**TOWN OF BROOKLYN
PLANNING AND ZONING COMMISSION
Regular Meeting Agenda
Wednesday, March 1, 2023 6:30 p.m.**

- a. Reading of Legal Notices:**
 - b. Continued Public Hearings:**
 - 1. **SP 22-008:** Special Permit Application for Multi-Family Development (50 Condominium units) on south side of Louise Berry Drive (Assessor's Map 33, Lot 19), 13.5 acres, R-30 Zone, Applicant: Shane Pollack and Erin Mancuso.

DATE: 4/23/2020	DRAWN: DNE
SCALE: 1" = 40'	DESIGN: NET
SHEET: 4 OF 16	CHK BY: GG
DWG. No: CLIENT FILE	JOB No: 20014

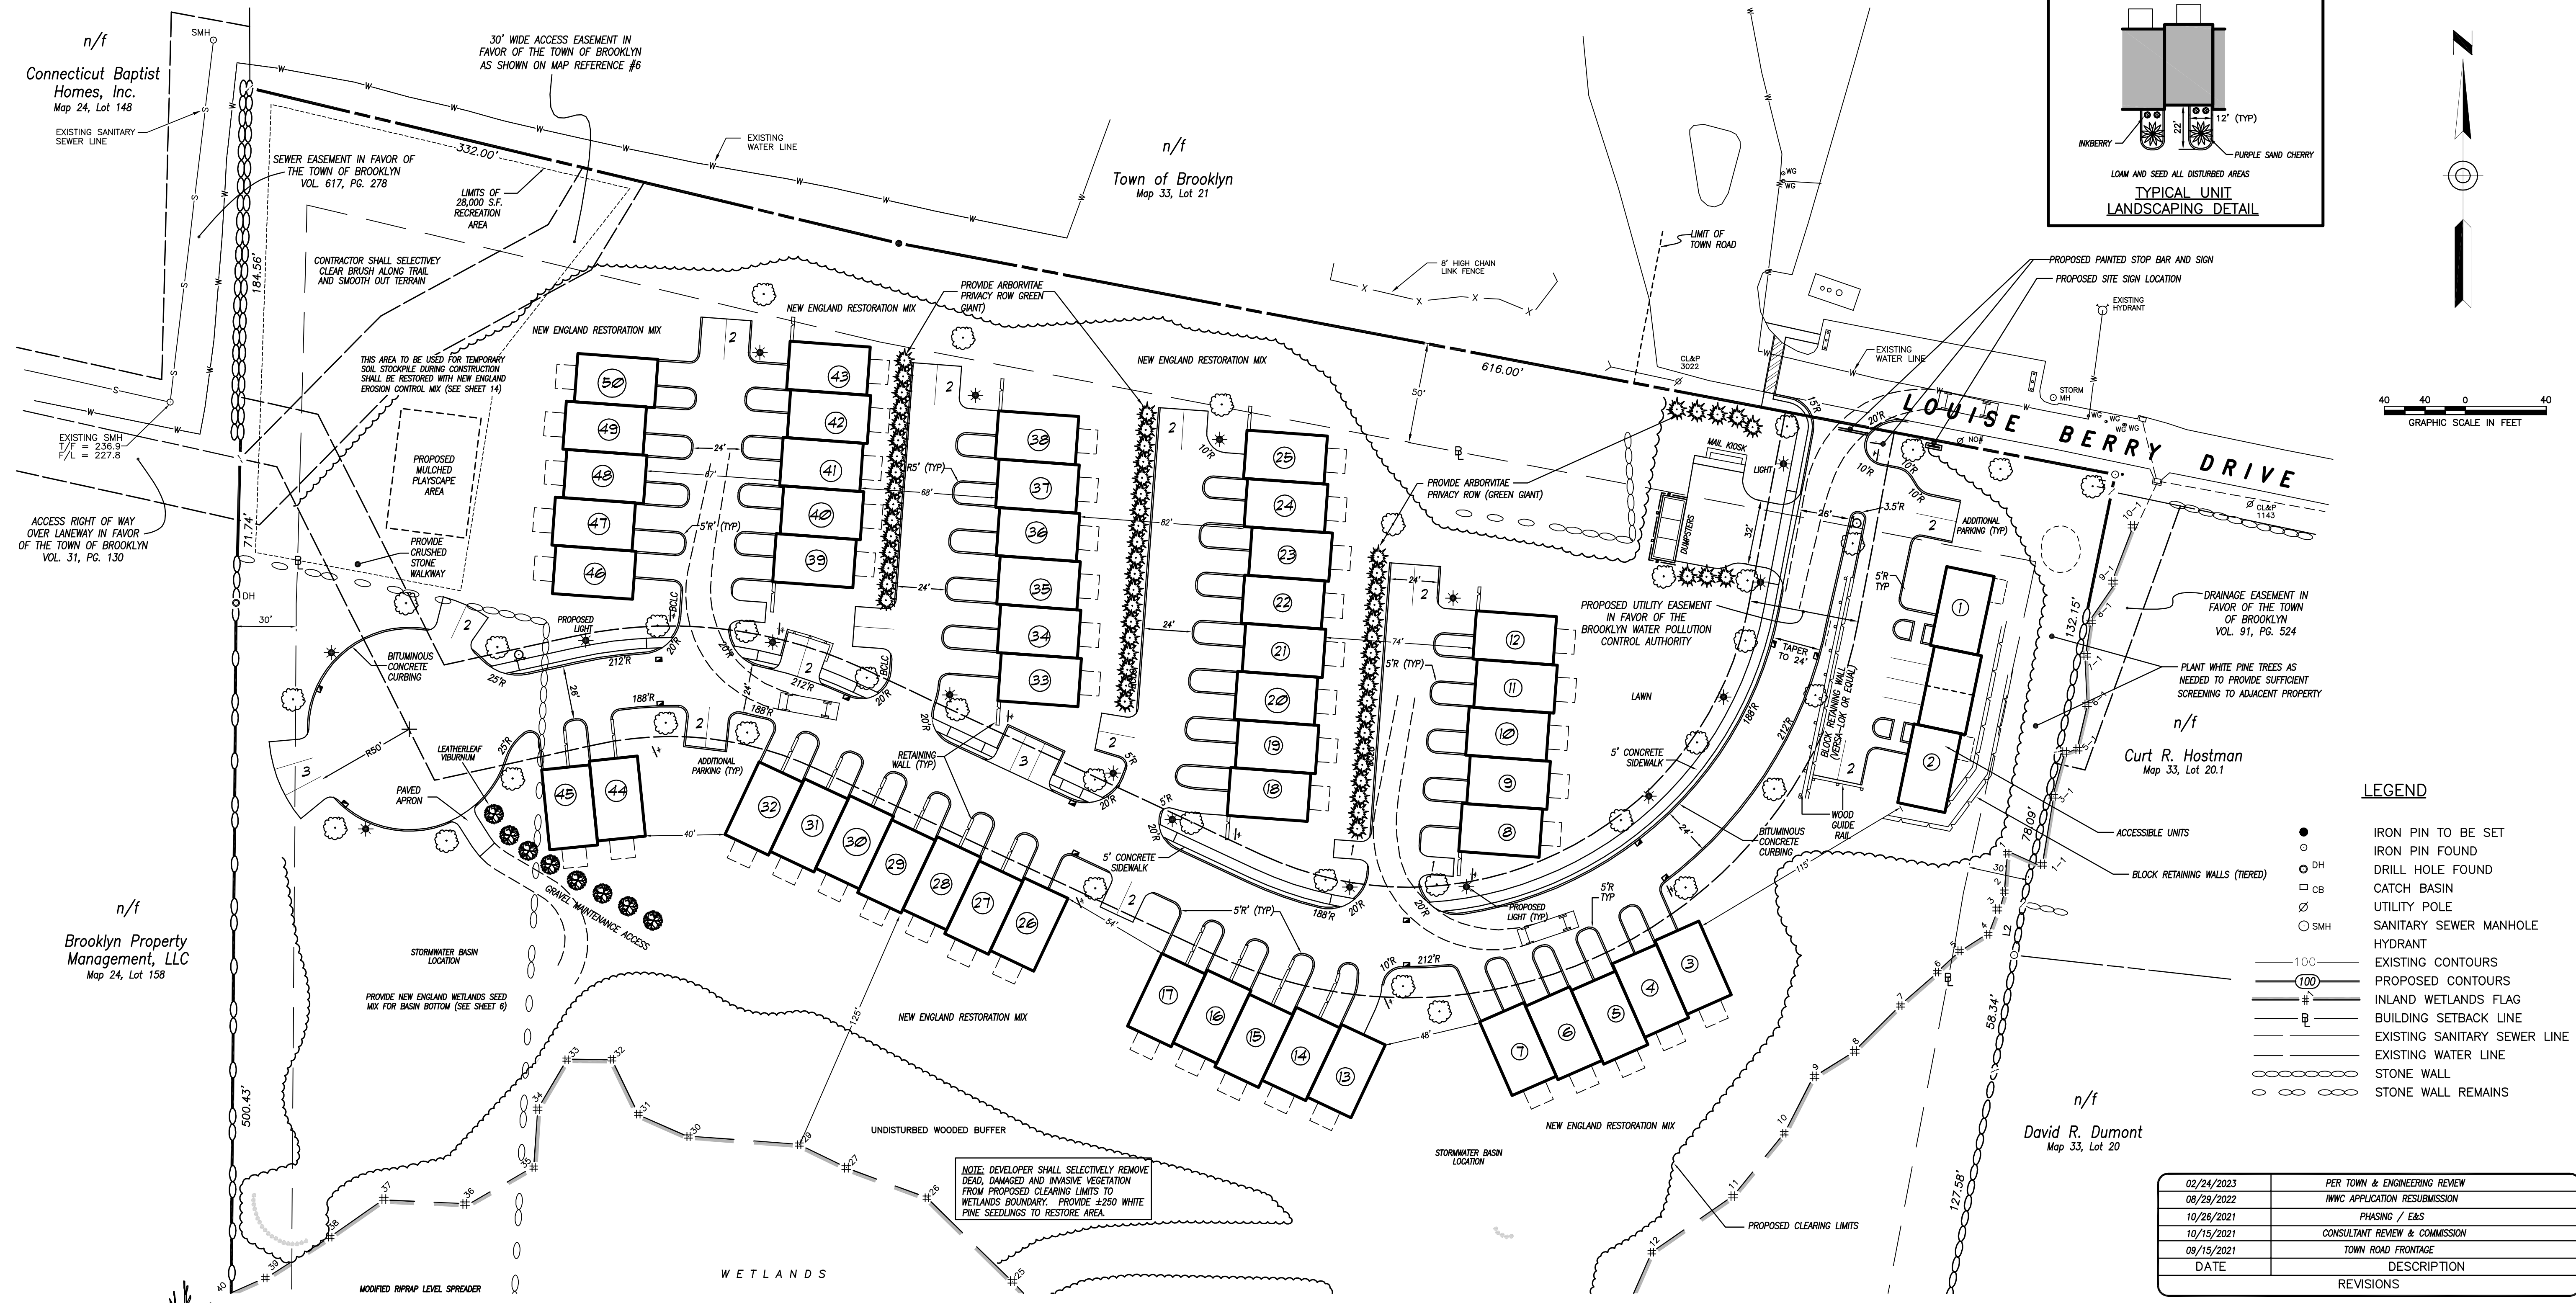
1. The title of the Site Plan (Sheet 4 of 16) might be better labeled "Final Build-Out Site Plan," or something similar, to indicate what the final site grading is expected to be, since the individual phasing plans only show intermediate grading that will be modified as construction of housing units progress toward the full build-out..

2. On the Site Plan (Sheet 4 of 16) the length of pipe P-14 measures approximately 36'. However, on the Road Profile plan (Sheet 7 of 16) the length of pipe P-14 is listed as 80' in the "Drainage Pipe Schedule" at the top left corner of the plan. This table needs to be corrected. The length of the pipe shown in the profile drawing is correct.

6.E.3.10.- On sheet 4 and other sheets, the dumpster locations may not be located within the front yard setback. They must be moved to a compliant location. The mailboxes are specifically exempt from the setback requirements and may remain in their current location.

1. The Title of sheet 4 (Site Plan) is a designation we have used for nearly 20 years in every municipality we work in. We do not see the reason why this title should be modified.
2. We have updated the pipe schedule on sheet 7 of 16 to reflect the correct length.
3. The pipe connection between CB-6 & CB-8 has been eliminated from phasing plans 3-5.

DATE: 4/23/2020	DRAWN: DNE
SCALE: 1" = 40'	DESIGN: NET
SHEET: 12 OF 16	CHK BY: GG
DWG. No: CLIENT FILE	JOB No: 20014

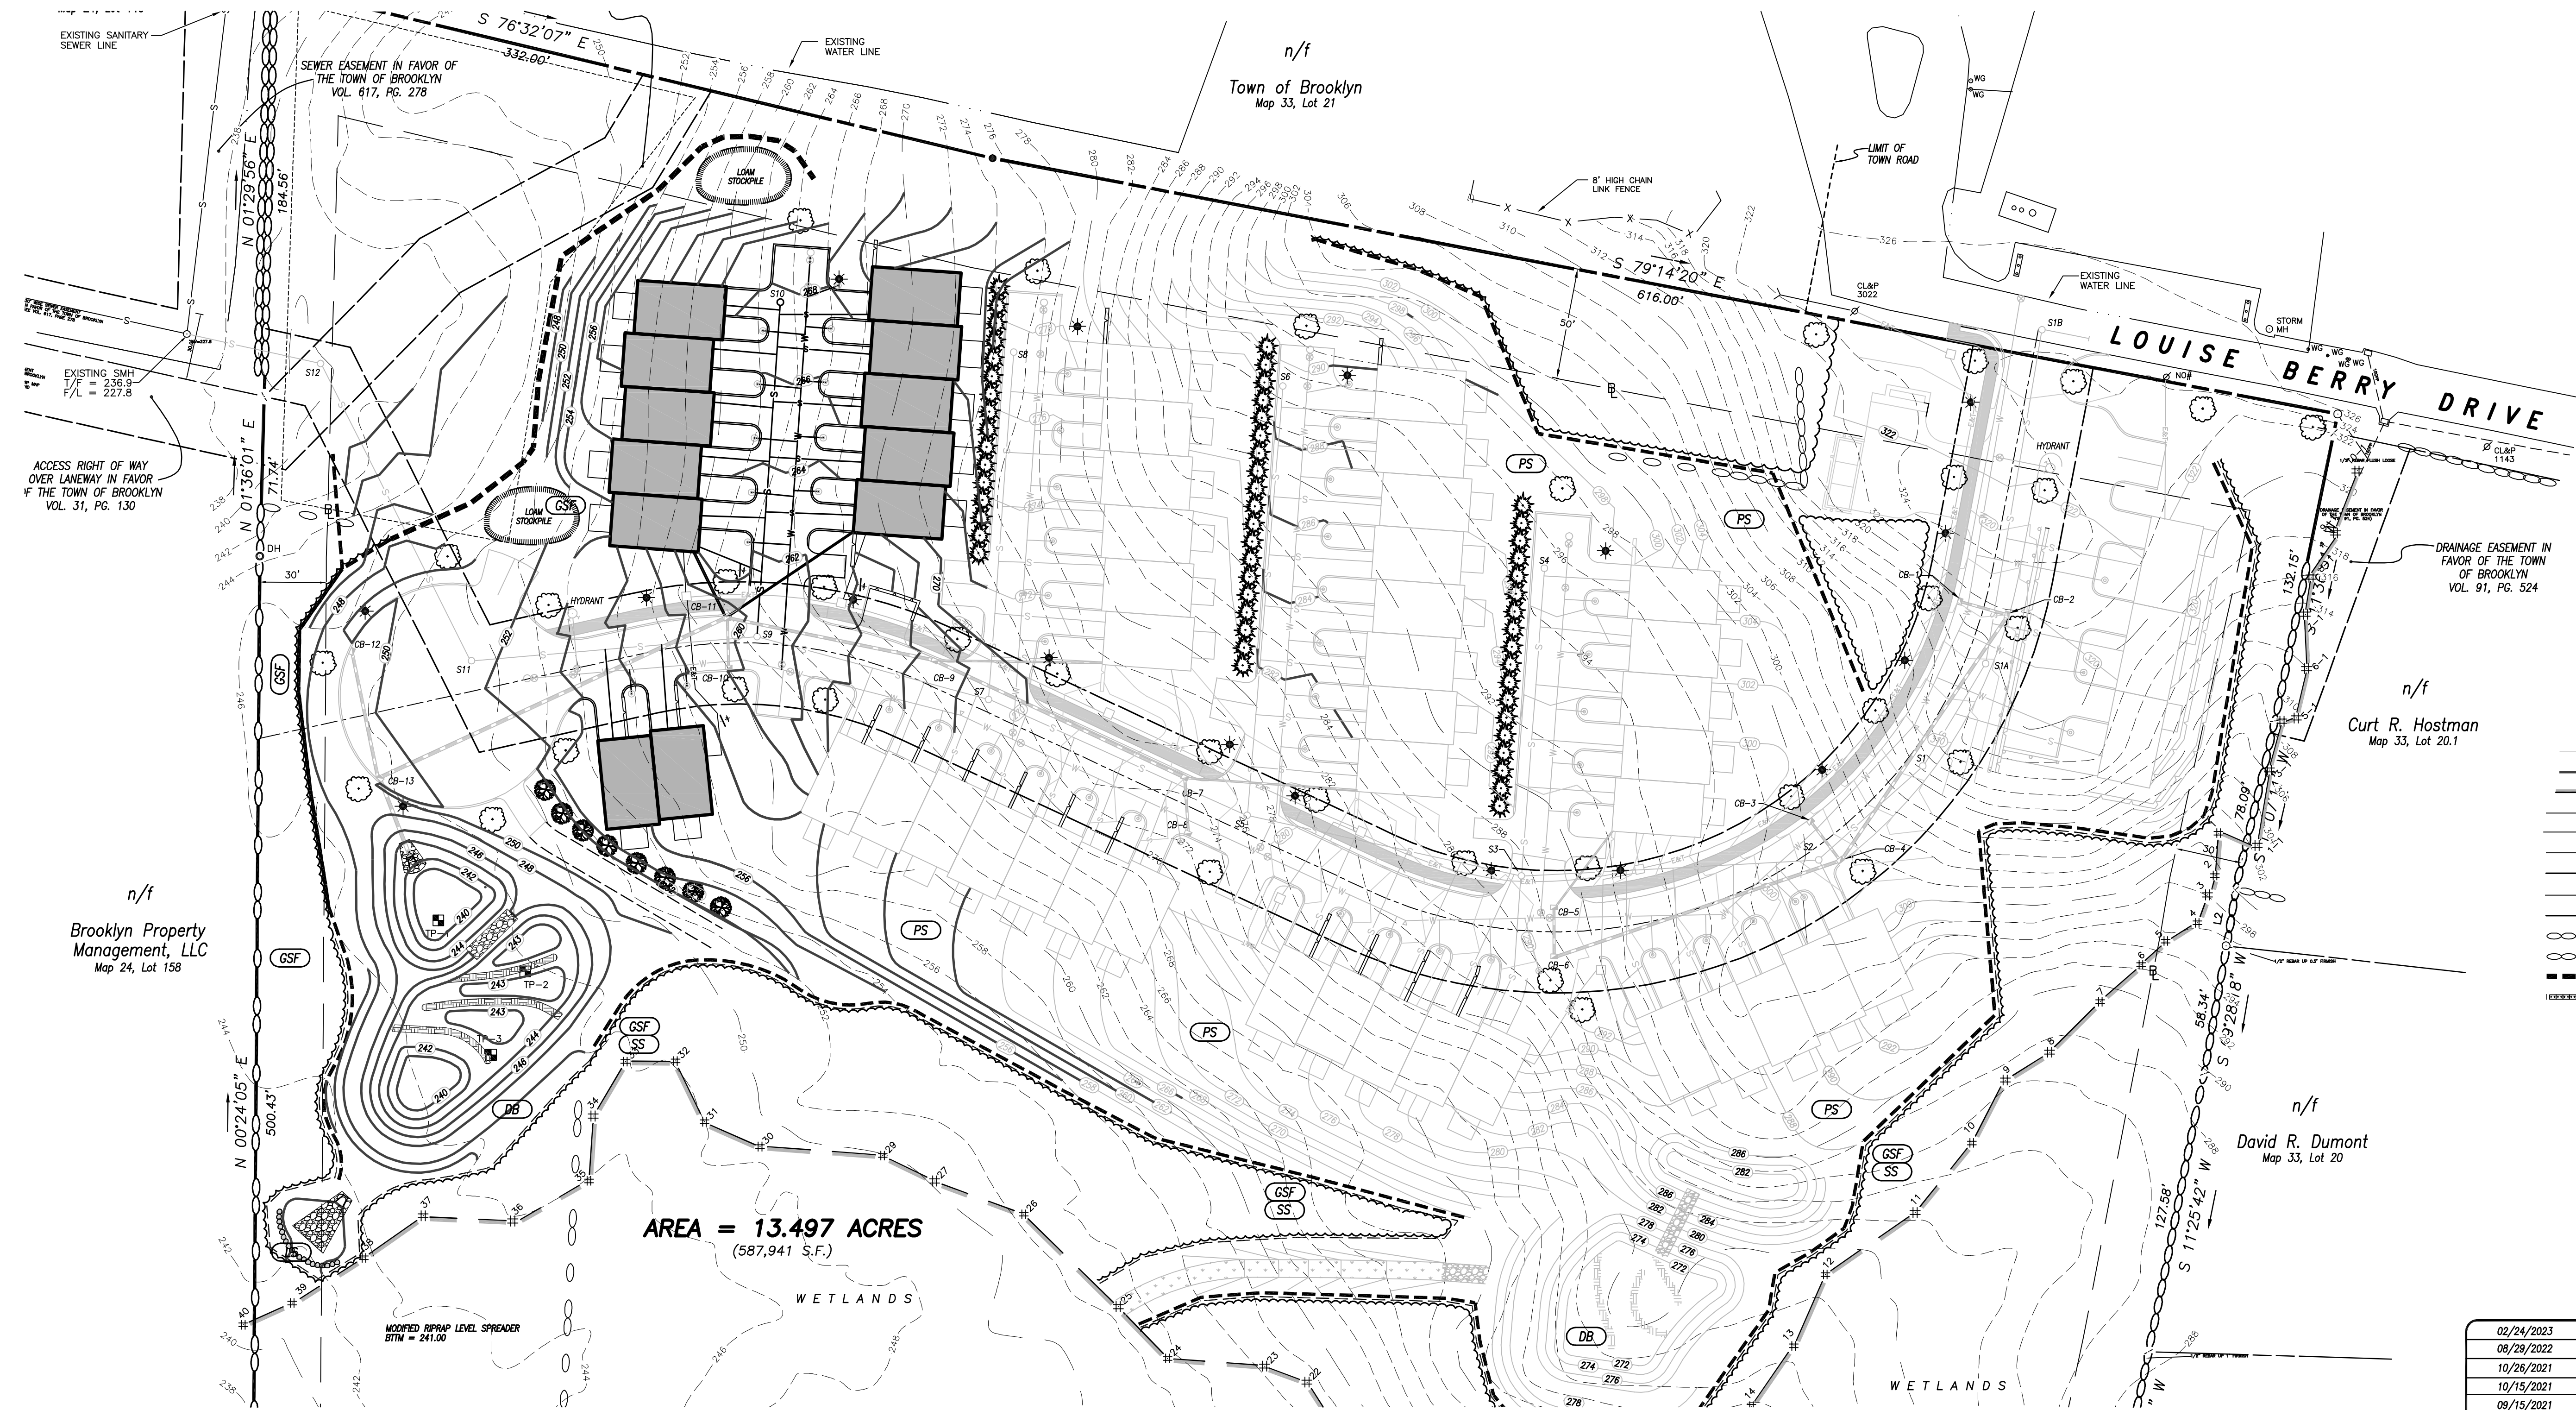
3. In Phase 3 thru 5 plans (Sheets 8 thru 12 of 16), the half-toned drainage system shown between CB-6 and CB-8 shows a pipe connection. This is incorrect and needs to be eliminated as it conflicts with that shown on the Site Plan (Sheet 4 of 16) and may cause confusion.

1. Final course of paving will be installed upon the completion of each phase. This is noted in the Development Schedule/Sequence of Operations on sheet 13;
2. Sidewalks have been shaded on the phasing plans to clarify their locations;
3. Tree plantings have been added to the phasing plans;
4. Street lighting has been added to the phasing plans;
5. On-street parking is shown on the phasing plans;
6. The road centerline has been added to the phasing plans;

7. Stockpiles have been added to the phasing plans;
8. Proposed contour lines have been adjusted accordingly for each phase to match final grades shown on sheet 4;
9. The sequence of construction will be repeated accordingly for each individual phase.
